# Preferred Infrastructure Report

Warragamba Dam Raising

Application Number	SSI-8441
EPBC ID Number	2017/7940

The purpose of this PIR is to describe changes to the CSSI Project since exhibition and in response to submissions. The PIR also contains responses or further information to address key issues raised by DPE.

Figure A1 Plan view of Project

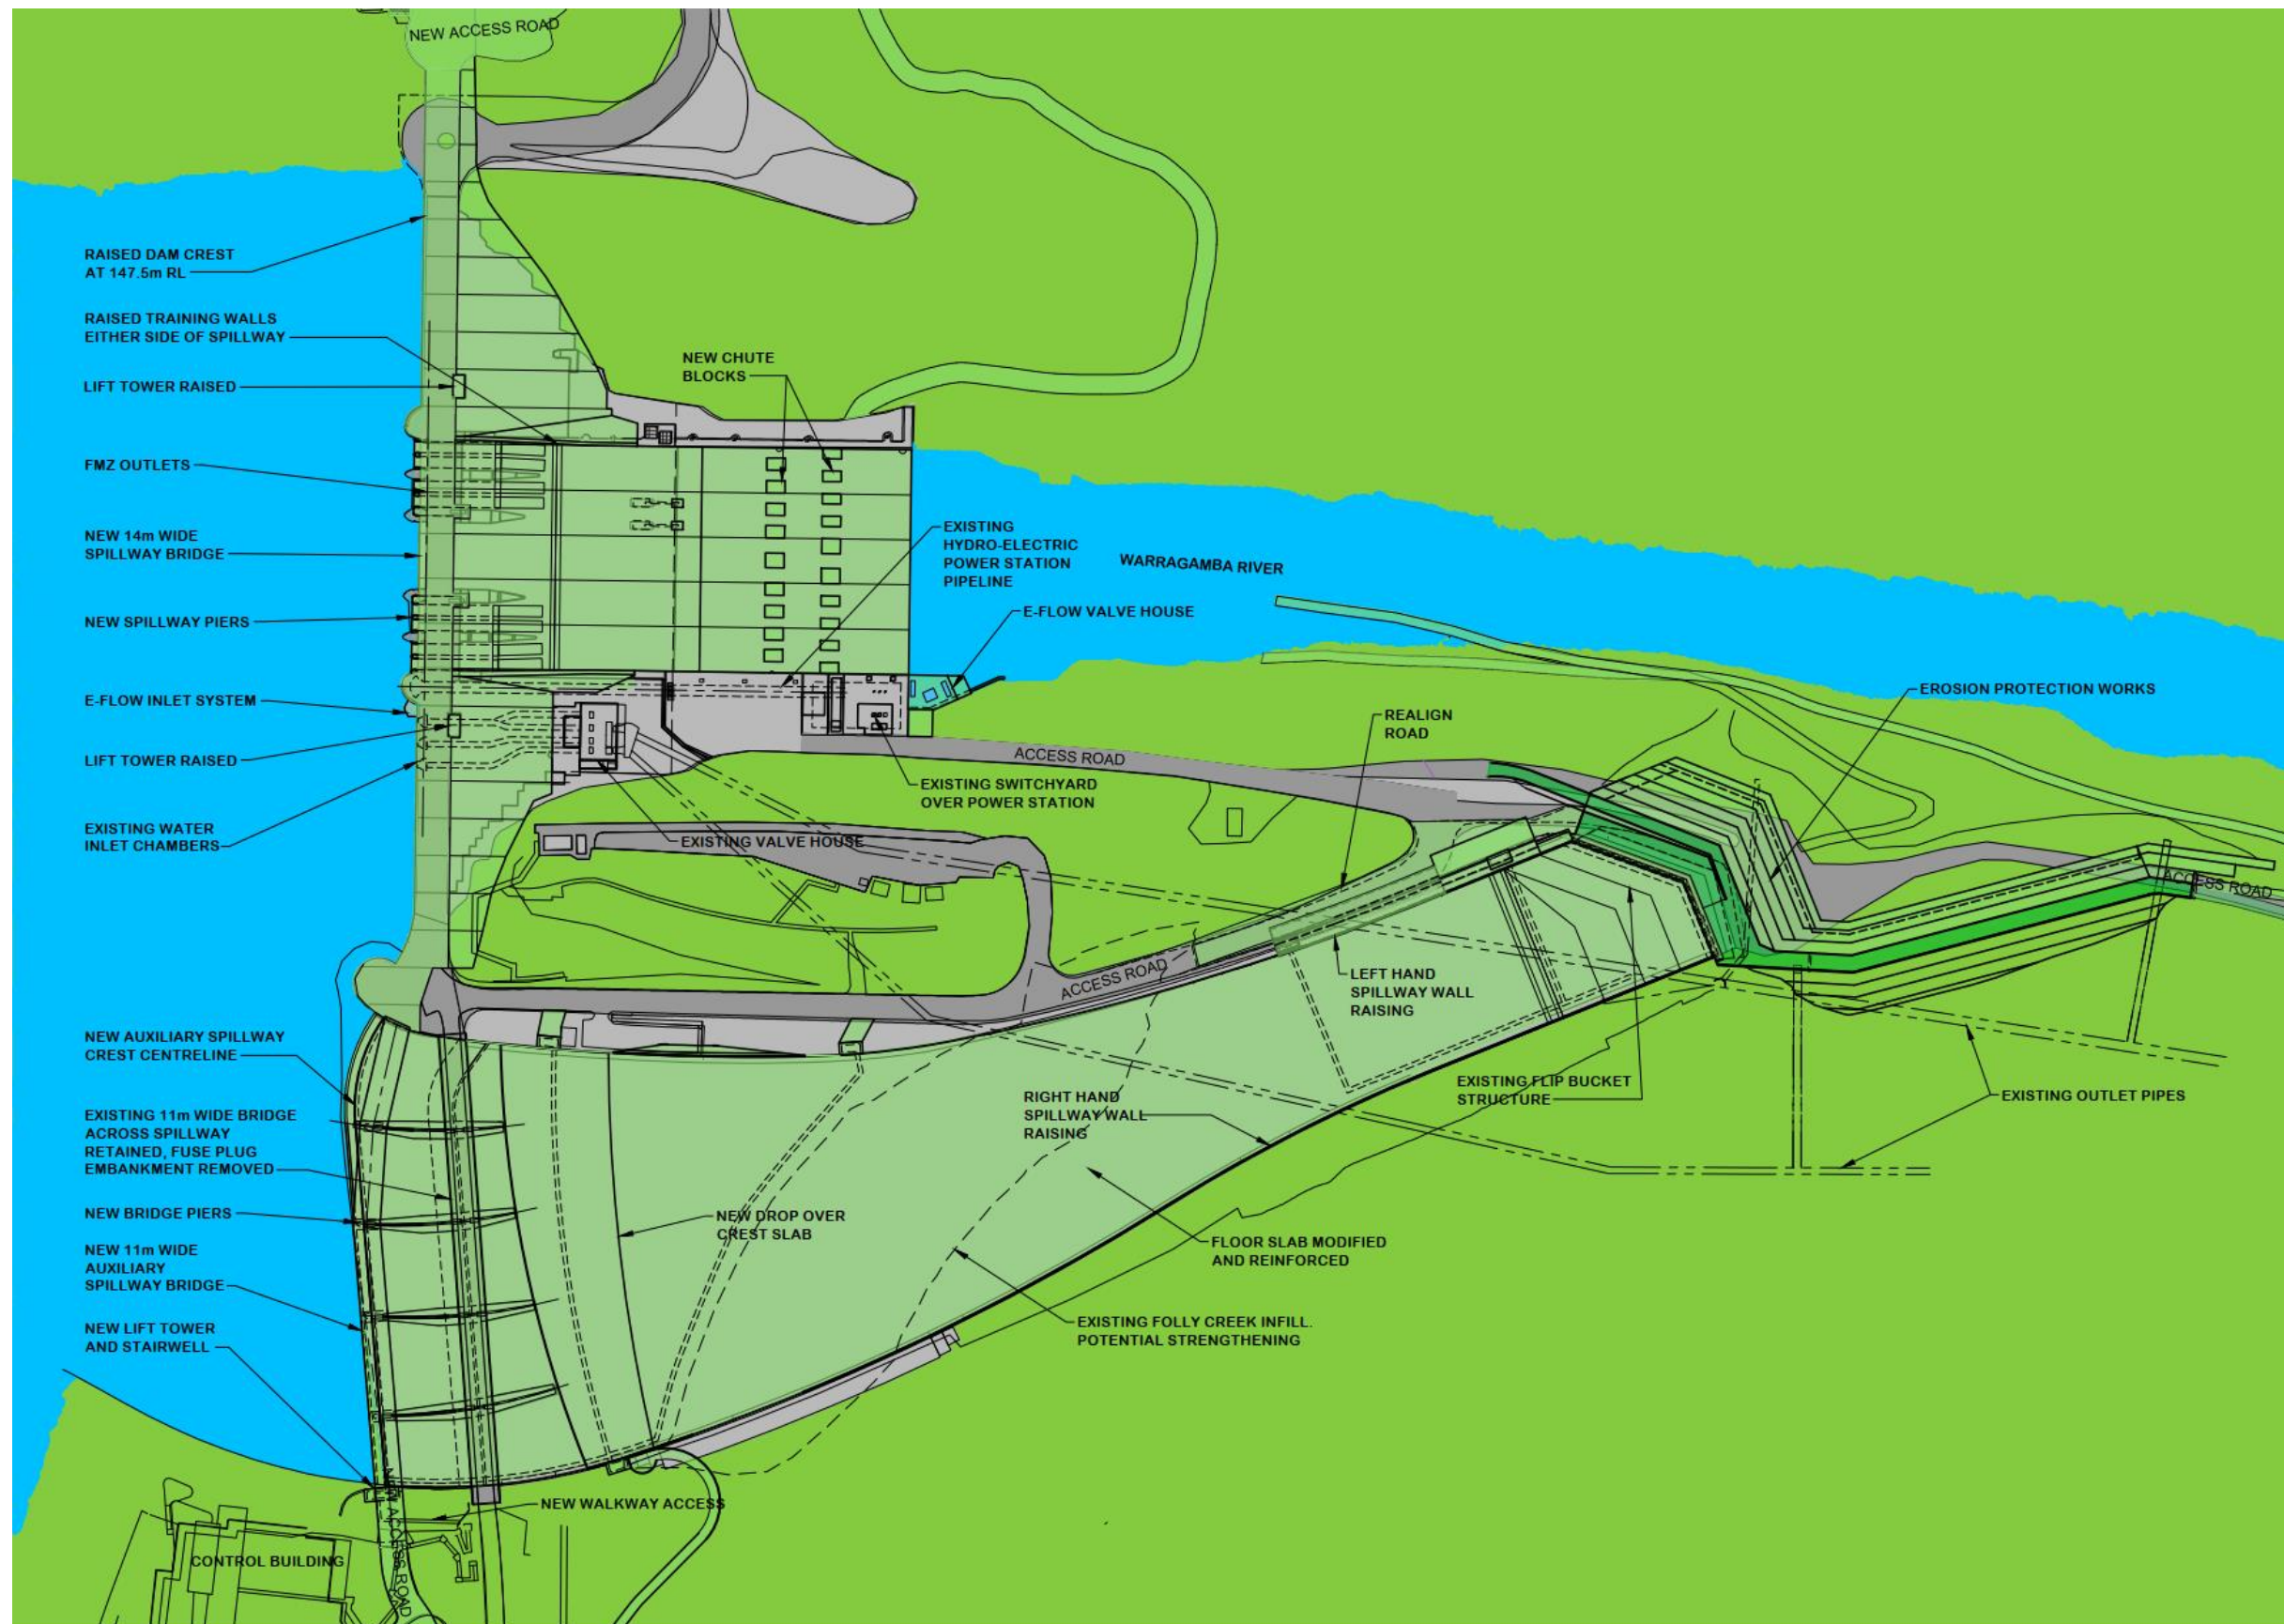
<b>Project Description</b>	
The Project Description should be reviewed and updated including, where required, relevant figures. For example, Figure 5-4 of the EIS shows a bridge below the lower dissipater slab of the dam. Figure C-5 of Appendix L does not appear to show a bridge in the same location, but further down the river.	PIR: Section 3 and Appendix A.

The Project description should be reviewed and updated including, where required, relevant figures. For example, Figure 5-4 of the EIS shows a bridge below the lower dissipator slab of the dam. Figure C-5 in Appendix L does not appear to show a bridge in the same location, but further down the river.

The Project description and related figures provided in the EIS describe the permanent changes to the dam structure and appearance. Any temporary works required for construction are not described in detail however may appear on figures such as the indicative location of a temporary bridge in Figure 5-4. Note that the image further down the river in Figure C-5 in Appendix L is the existing Warragamba Weir, not a bridge.

An updated Figure 5-4 is provided in Appendix A (Figure A14) to this report together with additional detailed concept design drawings. These drawings provide more detail and cross sections of the proposed works and have not required to be changed to address any of the submissions received from the EIS exhibition.
